# CITY OF PANAMA CITY BEACH

## ADDENDUM NO. 5

### PCB23-35 ITB Conservation Park Classroom

#### WALK PATH DETAIL

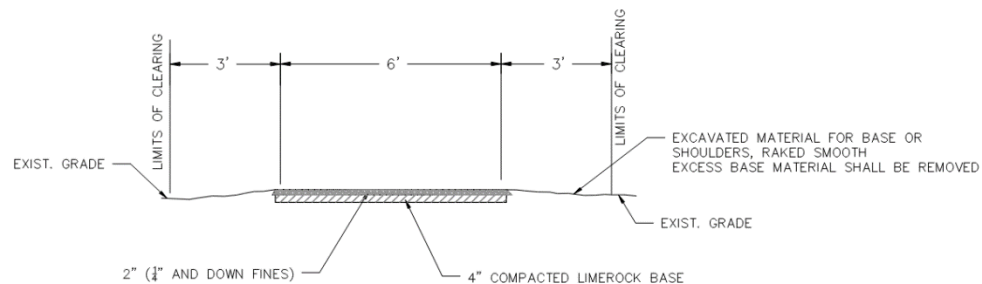
1. Please modify the proposed Asphalt Cross Section shown on Drawing C2 as indicated below.

*Delete this section in its entirety and substitute therefor the following section of the existing walk path pavement. Construct the proposed asphalt surface by removing/shaping the top 2 inches of quarter down material to accommodate overlay with 2 inches of SP 9.5 asphalt.*

1. THE SUB-GRADE BELOW THE PATH SHALL BE 4" CRUSHED LIMEROCK BASE AFTER COMPACTION W/ ONE -TO- THREE TON ROLLER. THE SUB-GRADE SHOULD BE CHECKED FOR UNIFORMITY AND SHOULD BE FREE OF ANY DEBRIS, STONES, LOOSE SOIL, ETC. PRESOAK ALL AREAS OF APPLICATION BEFORE INSTALLING PATHWAY.

2. SPREAD THE PATH SURFACE MIX AS EVENLY AND SMOOTHLY AS POSSIBLE. THE FINAL COMPACTED DEPTH SHALL BE A MINIMUM OF 2" FOR PEDESTRIAN TRAFFIC.
3. WATER THE NEWLY SPREAD PATH UNTIL IT HAS BEEN PENETRATED THE FULL DEPTH OF THE MATERIAL. BE SURE NOT TO OVER WATER AND CREATE A MUDDY PATH.

4. USING A ONE- TO THREE-TON ROLLER OR VIBRATORY PLATE COMPACTOR, COMPACT THE PATH. WHERE SPACE IS TIGHT AND DOESN'T ALLOW FOR A ROLLER OR PLATE COMPACTOR, HAND TAMPING CAN BE DONE WITH MULTIPLE PASSES. ONCE COMPACTED, CHECK FOR DIPS AND UNEVEN AREAS, ADDING AGGREGATE AND COMPACTING AS NEEDED TO ELIMINATE LOW SPOTS

5. ALL MATERIALS TO BE IN ACCORDANCE WITH APPLICABLE SECTIONS OF LATEST ADDITION FDOT STANDARD SPECIFICATIONS FOR ROAD AND BRIDGE CONSTRUCTION, PARTICULARLY SECTION 220 (LIMEROCK BASE).

6. LIMEROCK TO BE SOURCED FROM A CURRENTLY APPROVED FDOT PIT.
